HISTORIC PRESERVATION BOARD

HISTORIC PRESERVATION BOARD MEETING

WORKSHOP
40-46 FREE STREET

TO: Chair Sheridan and Members of the Historic Preservation Board
FROM: Deb Andrews, Historic Preservation Program Manager
DATE: April 24, 2019
RE: May 1, 2019 WORKSHOP – Preliminary Review of Proposed Mixed-Use Construction

1 PROPOSED WEST EXTERIOR ELEVATION
1/8" = 1'-0"

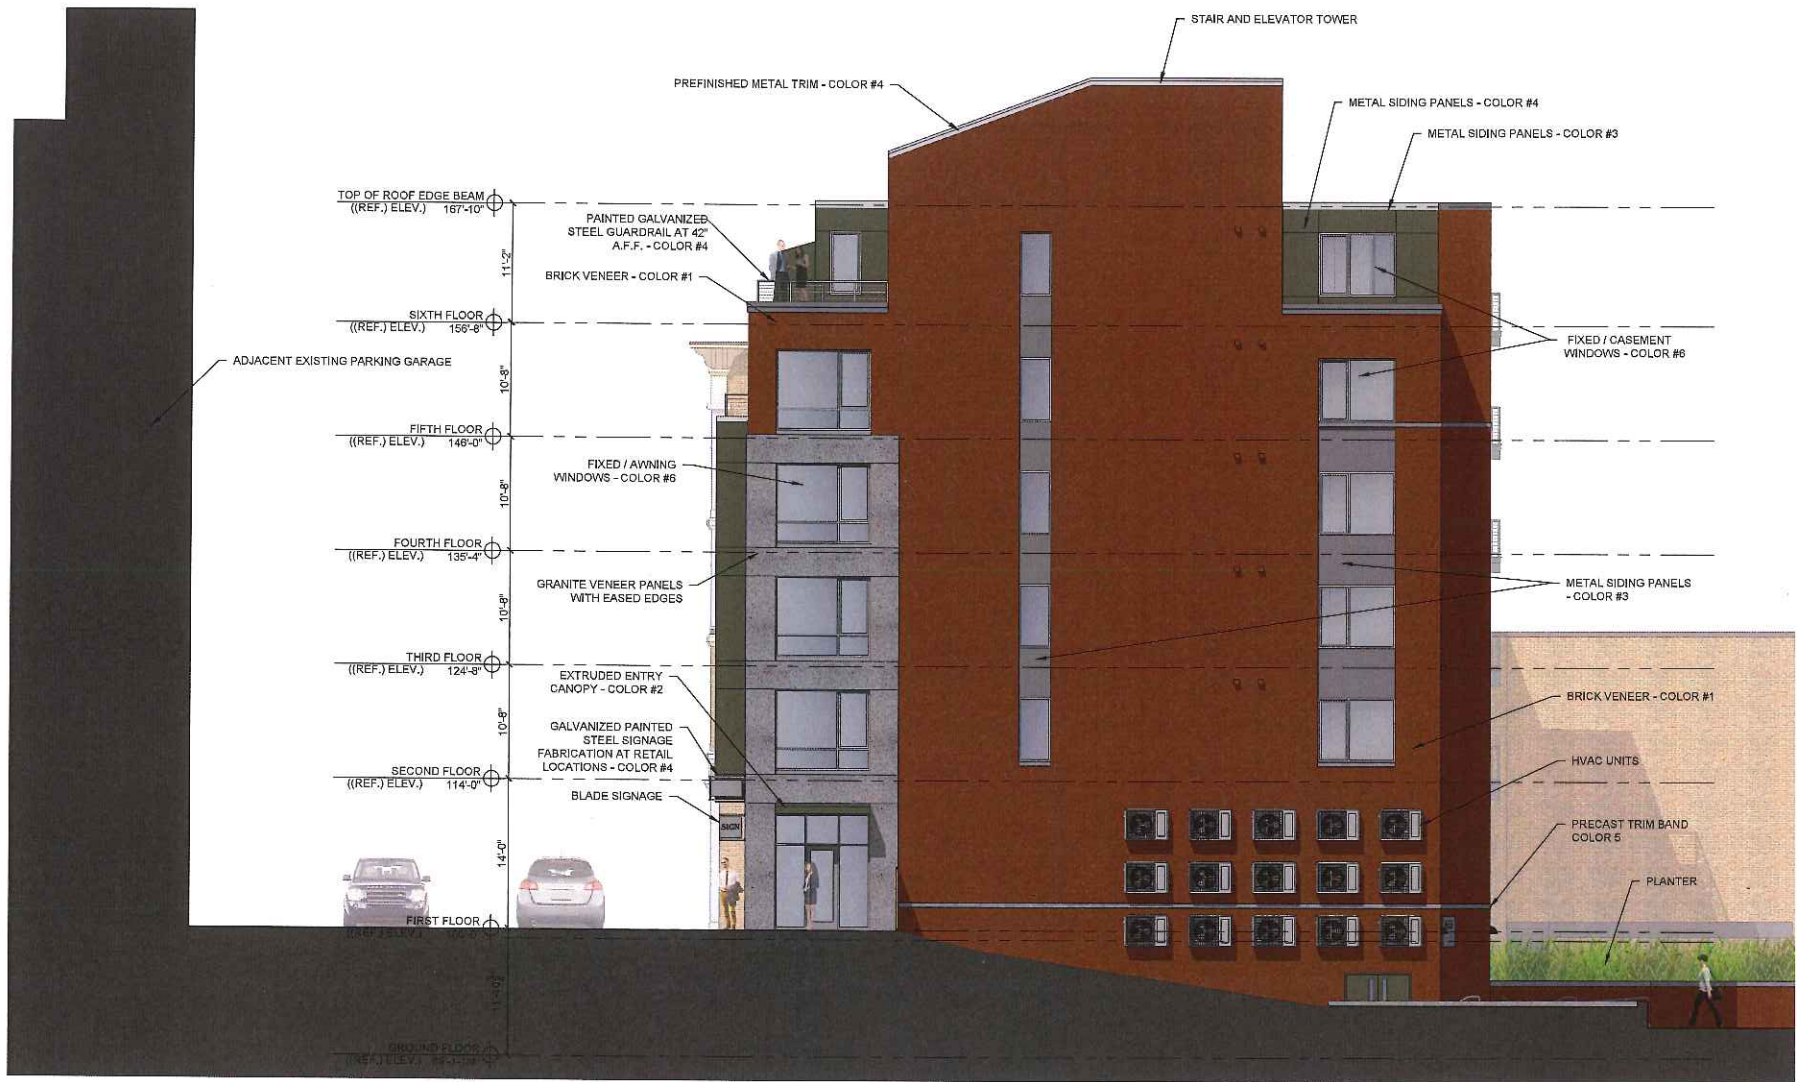
Given the spacing between this building and its abutments on both sides, the east and west elevations will be clearly visible. On the west wall, granite turns the corner from the front façade for a distance of one bay, terminating at the fifth-floor level. Otherwise, the exterior is clad in brick. The entrance to the upper floor apartments is located on this elevation, near the Free Street corner. The center portion of the upper facade includes only a continuous narrow vertical strip of windows. Stacked square window openings are shown at each end. The center portion of the west elevation extends well above the sixth-floor level, accommodating a stair tower and elevator overrun. A portion of the stair tower roofline is pitched to mitigate its overall height. A fence with gate extends the width of

the opening between the proposed development and the abutting building. The fence is positioned just beyond the apartment entry and obscures the view of 15 heat pumps installed on the lower portion of the wall at the building's southwest corner.

** It is clear from the submission that the number of required mechanicals is significant—see heat pumps on south and west elevations in addition to rooftop mechanicals. Every effort should be made to minimize the visibility of mechanicals. Staff questions whether the mechanicals will be visible as viewed from Spring Street Arterial; the rendering of that view suggests not. The Board will want to confirm that. If visible, perhaps consideration should be given to “corralling” the mechanicals in a continuous screen.*

1 PROPOSED EAST EXTERIOR ELEVATION
1/8" = 1'-0"

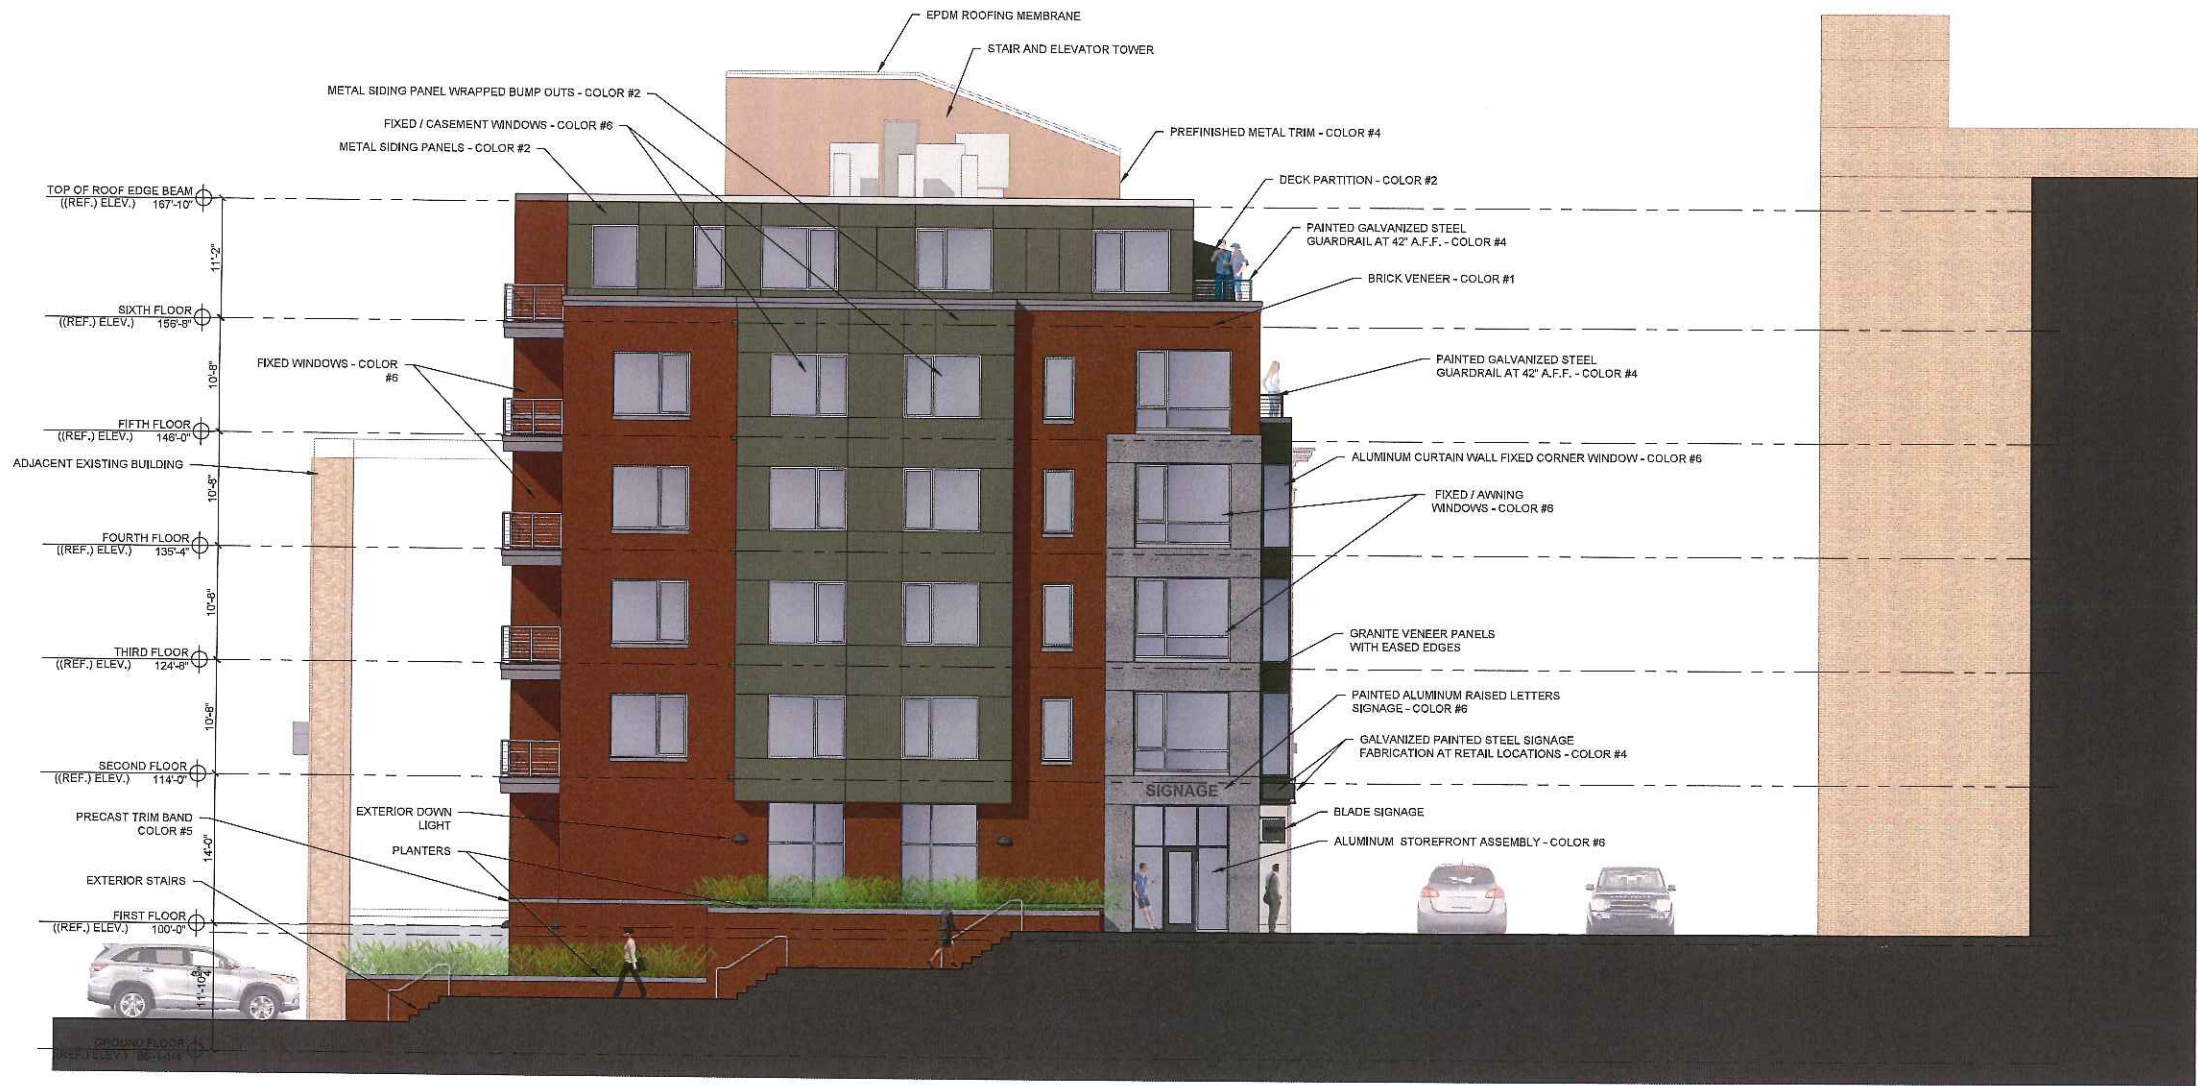
The east elevation is more highly glazed and, unlike the west elevation, reads as a more primary façade. As with the west elevation, the granite treatment at the corner extends four floor levels for a distance of one bay. A double-wide projecting bay, clad in metal panels, is centered on this elevation and extends to the cornice above the fifth floor. At the southeast corner of the building, near the rear parking area, the building steps back to include a series of corner decks serving all upper floor levels.

1 ROOF PLAN
1/8" = 1'-0"

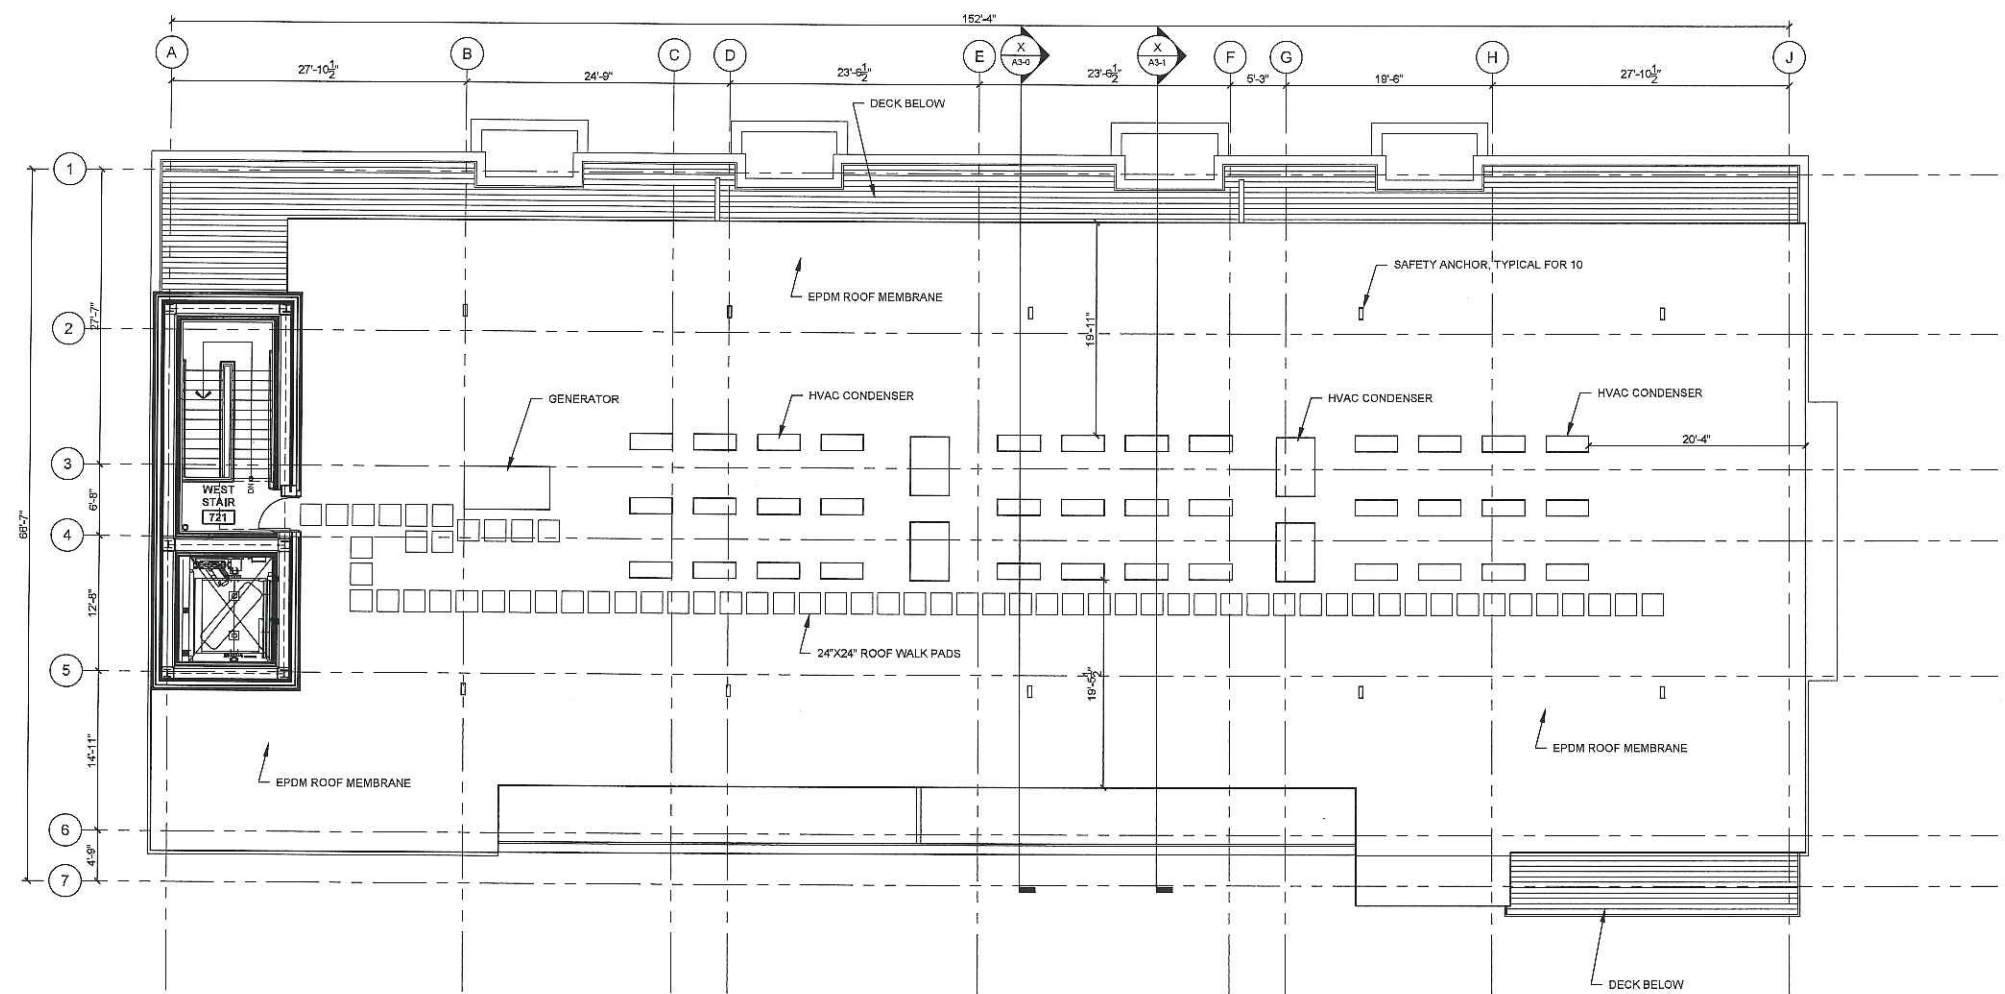
**Regarding the elevator overrun at the western edge of the building, the Board might ask what is dictating its overall height. Does the elevator need to provide access to the roof? Can it be reduced? Given its position at the edge of the roof, it exaggerates the building's height as one approaches from the west—see perspective view.*
